NOTICE OF MEETING
PLANNING AND ZONING COMMISSION
6:00 P.M. – January 14, 2021
30360 Cougar Bend, Bulverde, TX 78163

PLANNING AND ZONING COMMISSION ITEM:
PC-20-02
FINAL PLAT
JOHNSON RANCH NORTH UNIT 9

SUBJECT: Johnson Ranch North Unit 9
Final Plat / Construction Plan Acceptance

LEGEND

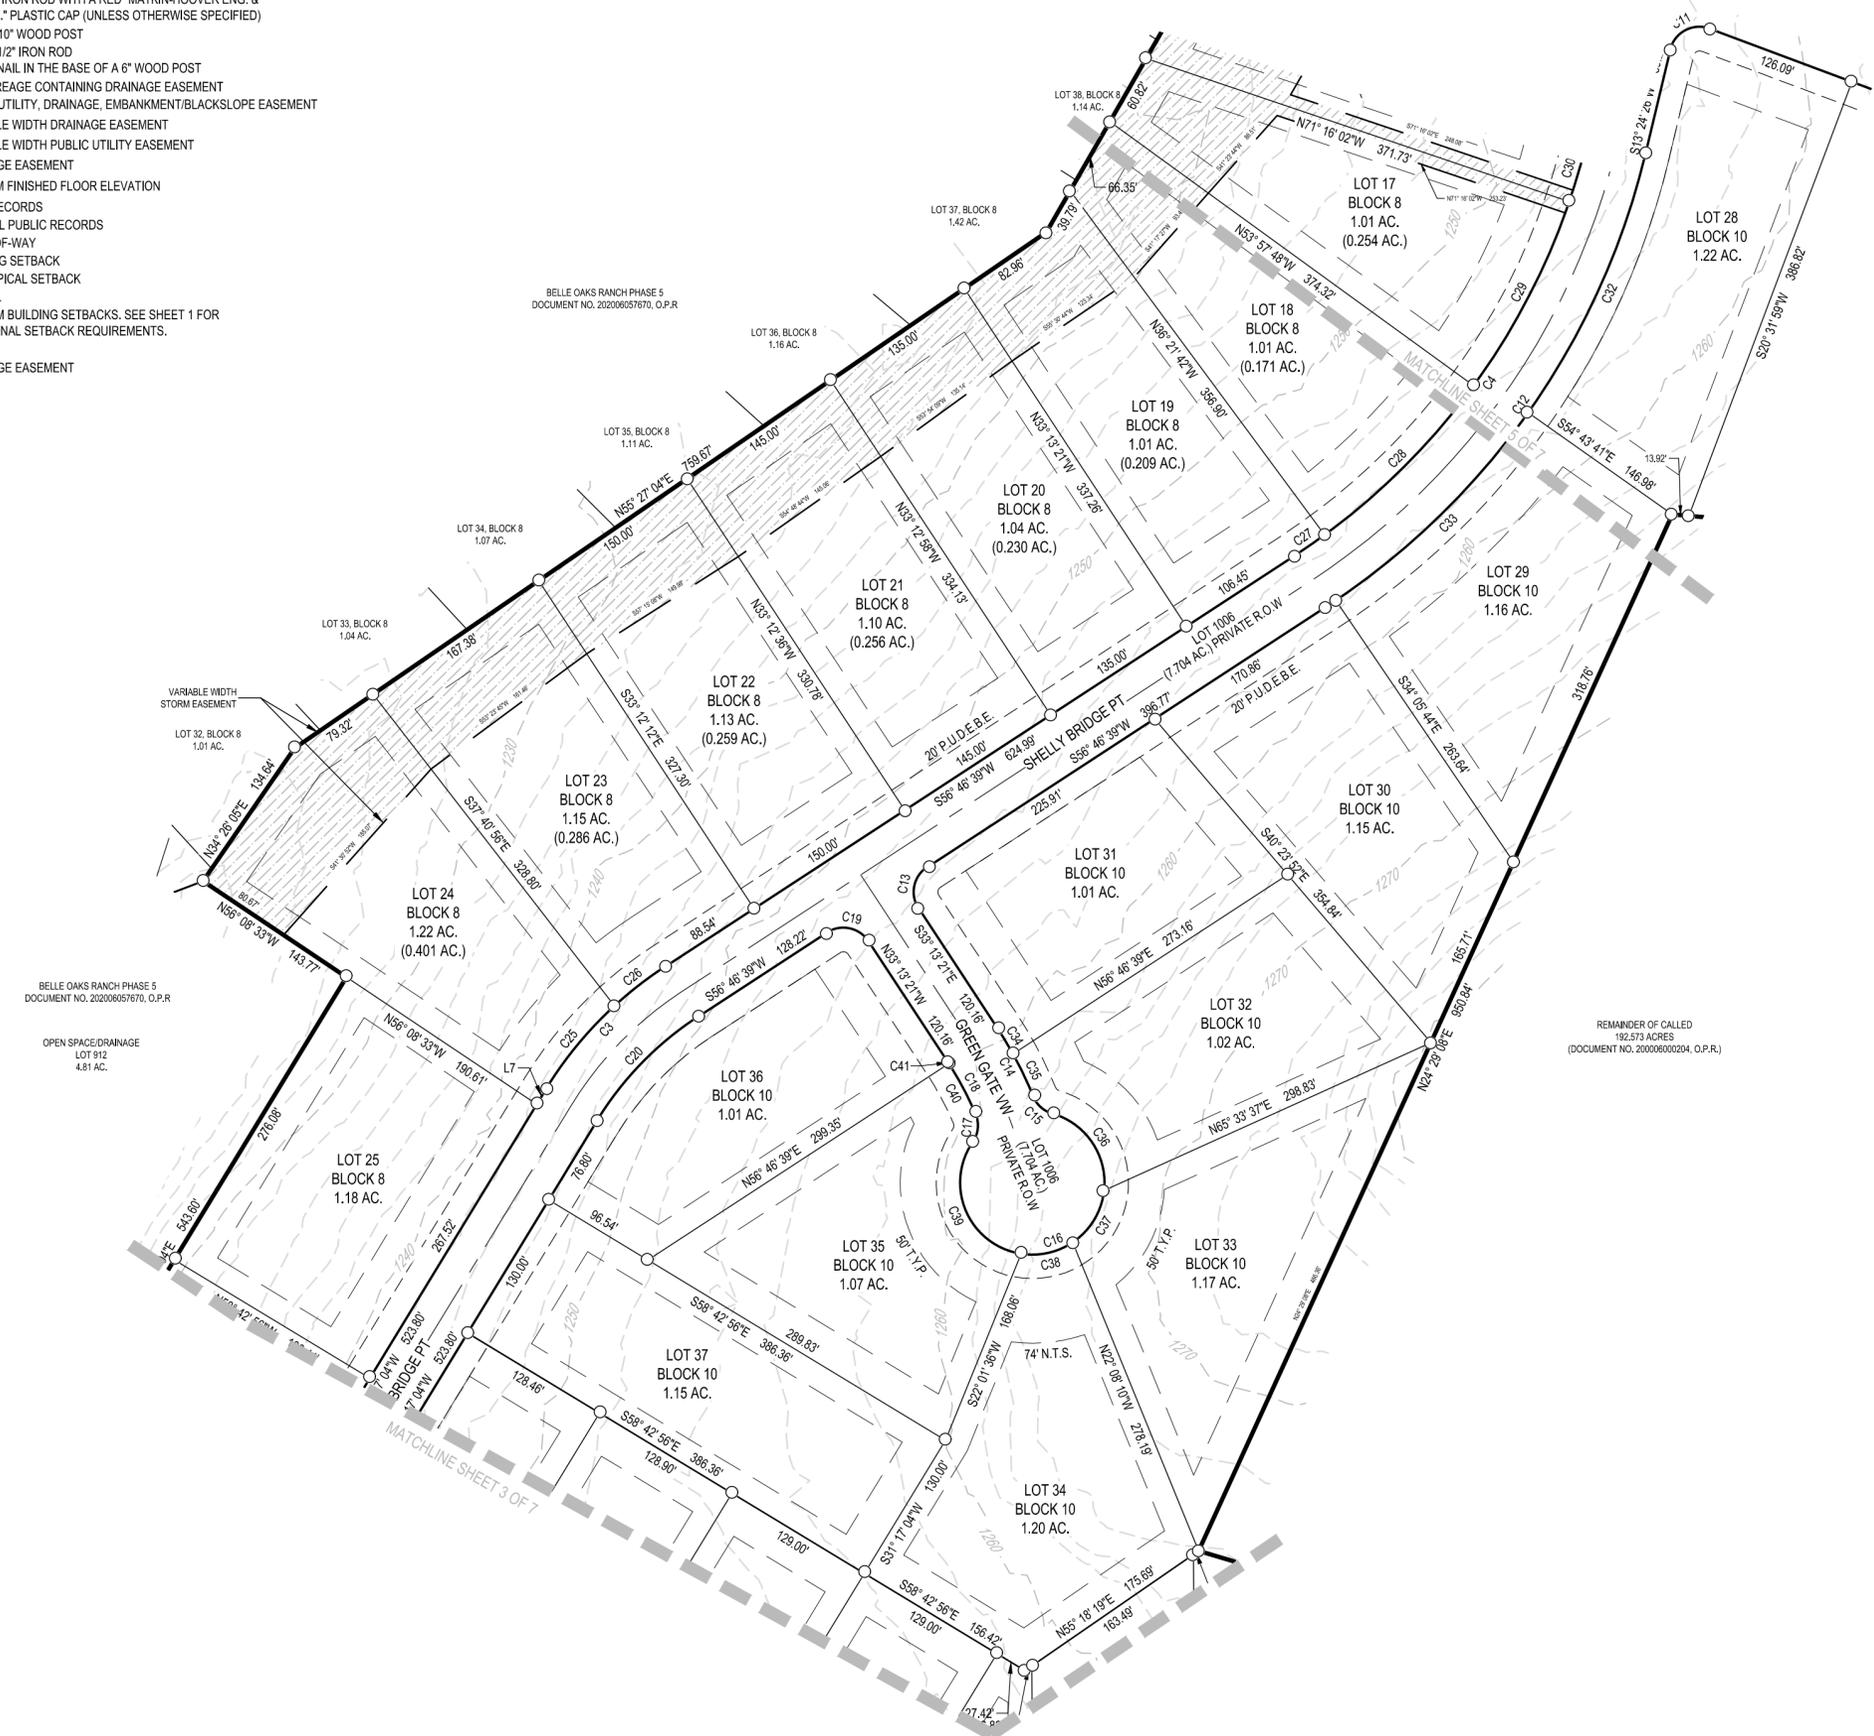
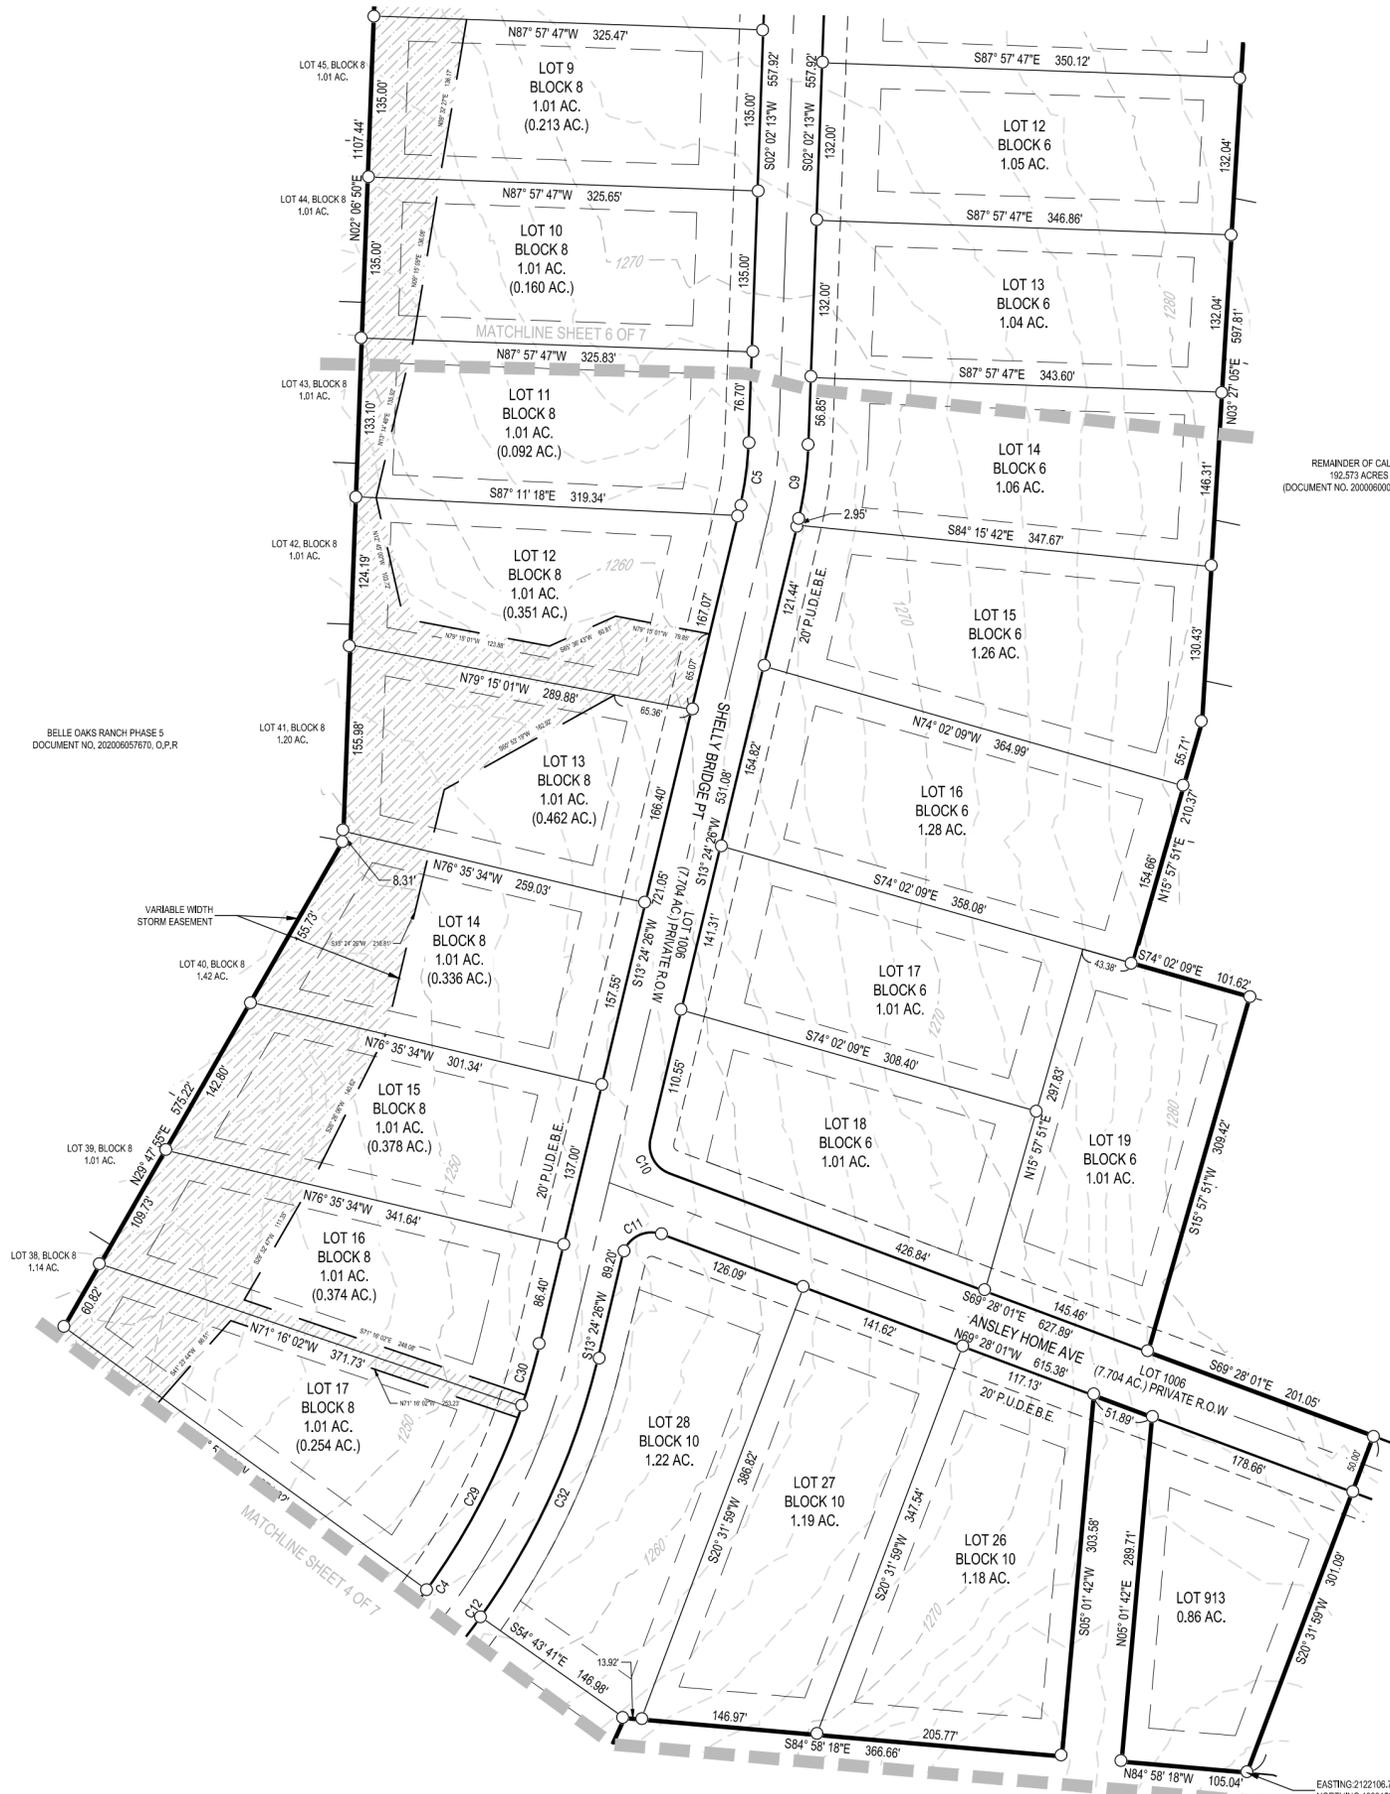
- MDP limits the # of lots for Phase 6 to 74 lots, but plat sheet 1 says “77” lots and 82 were counted. Please revise to max shown on MDP or update MDP. – **Comment resolved...the last approved MDP, dated 10/15/2019, showed 615 total lots for the development. Since then, the Phase 5 & 6 boundaries have been adjusted to address City comments and 4 lots have been moved from Phase 5 to Phase 6, but the total lots have not increased for the development.**

4. FEMA floodplain/drainage easement missing from Lot 34, Block 1. – [Comment resolved](#)

5. Verify that fire hydrant spacing is within requirements. There are multiple areas that seem to have more than 500' of street distance between hydrants (as measured along the water line/easement). – [Comment resolved](#)

6. The following lots do not appear to meet minimum frontage requirements (105 feet):
 - a. Lot 17, Block 1 – [Comment resolved](#)
 - b. Lot 18, Block 1 – [Comment resolved](#)
 - c. Lot 19, Block 1 – [Comment resolved](#)

7. The following lots do not appear to meet the maximum aspect ratio requirements (4 to 1):
 - a. Lot 34, Block 1 – [Comment resolved](#)
